**E3643A-01**

# S E R V I C E N O T E

## E3643A DC Power Supply

**Display went off during power On.**

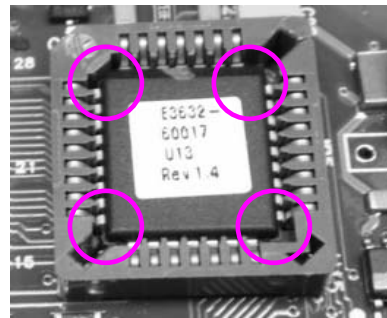
1. Upon turn on the power supply, if the symptoms are as follows:
  - a. Display light up and then become blank with fan running
  - b. Display light up and hang with fan running
2. Turn OFF the power supply.
3. Remove the existing EPROM and replace with a known good EPROM.
4. Refer to the reference designator of EPROM according to model:

5. Turn ON the unit again and see if the symptom disappears.
6. If the symptom still occurs, turn OFF the unit.
7. Return the unit to factory for Failure Analysis.
